Re: WDNR BRRTS #02-41-552537  
Amendment #1 to the Site Investigation Workplan  
Westwood Dry Cleaners  
8731 W. North Ave  
Wauwatosa, WI 53226

Re: REQUEST FOR A VARIANCE TO WIS. ADMIN CODE, § NR 141.19  
WDNR BRRTS #02-41-552537  
Westwood Dry Cleaners  
8731 W. North Ave  
Wauwatosa, WI 53226

# **SITE INVESTIGATION WORKPLAN**

September 7, 2017  
**Revised June 21, 2018**  
**Amended July 26, 2018 (After WNDR's Review)**

<b>SITE NAME</b>	Westwood Dry Cleaners (#02-41-552537)	<b>FIGURE NO.</b>	3
<b>FIGURE NAME</b>	Proposed Sampling Location Map		
<b>ADDRESS</b>	8731 West North Avenue, Wauwatosa, WI 53226

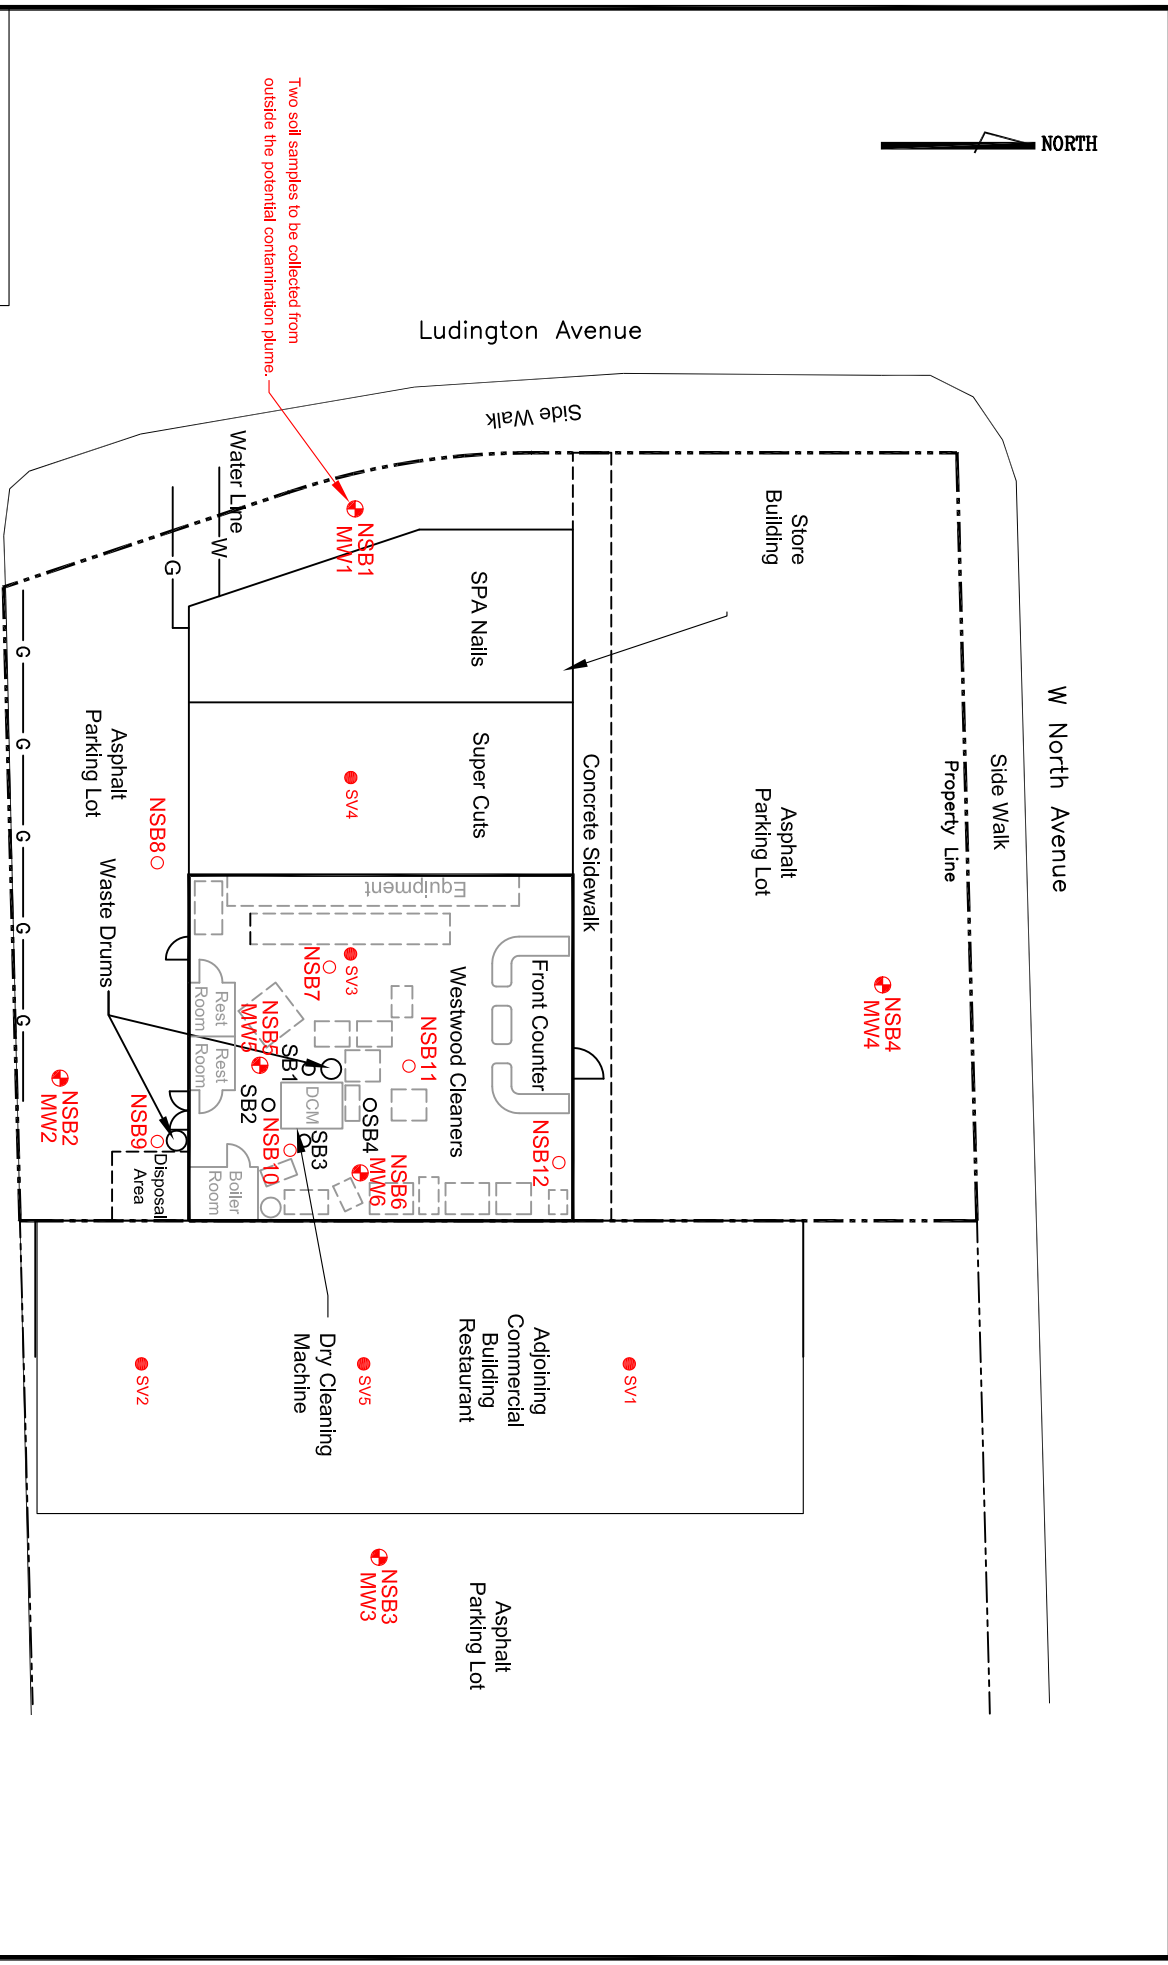
- 1. The DNR agrees with all the sampling locations as proposed. However, the DNR is requesting that a third vapor sampling point (SV-5) be located east of sampling location NSB6/MW6 across and inside of the adjoining Commercial Building, Restaurant.*

Response: HDC, Inc. has added a third vapor sampling point (SV-5) at your proposed location. Please see the attached revised Proposed Sampling Location Map for location confirmation.
